**INDEPENDENT SAFETY AND QUALITY
ENGINEERING DEPARTMENT**

**GENERIC LETTER 89-10
MOTOR OPERATED VALVE
PROGRAMMATIC ASSESSMENT**

TQE ASSESSMENT NO. 93-02

**PALO VERDE
NUCLEAR GENERATING
STATION**

PVNGS MOV GL 89-10 ASSESSMENT
 Test, Evaluation, and Rework Process For GL

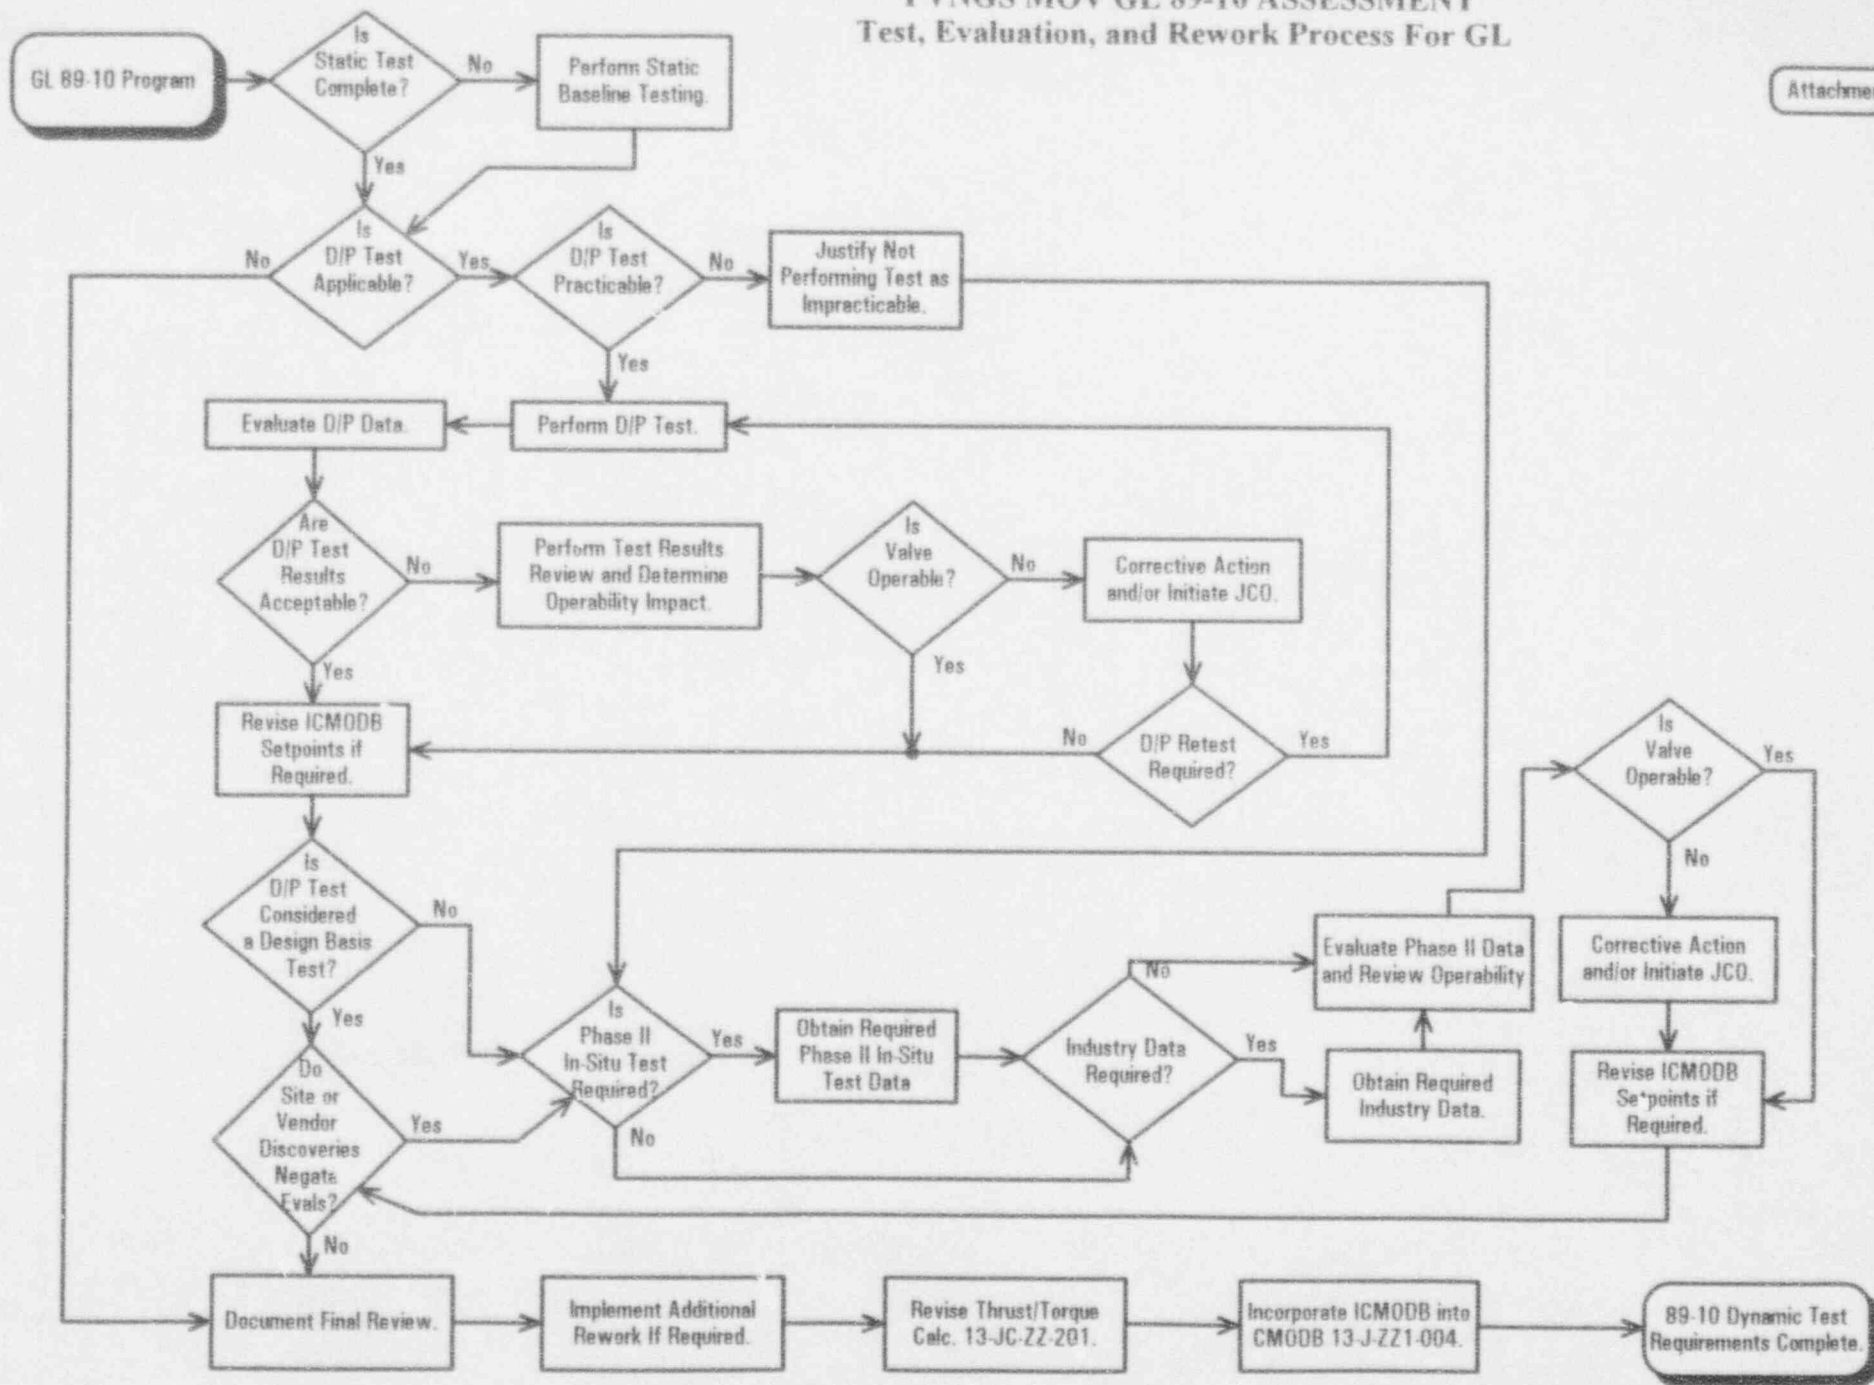
Extensive evaluation and corrective actions (i.e., revision of MOV calculations, valve modifications, and/or valve retesting) may be required following dynamic testing as depicted in Attachment F. These activities are not included in the program schedule. From discussions with Valve Services Department personnel it has been concluded that the scope of the program required to be complete to satisfy GL 89-10 has not been clearly defined. The generic letter requires that the NRC be informed, if the program schedule cannot be met.
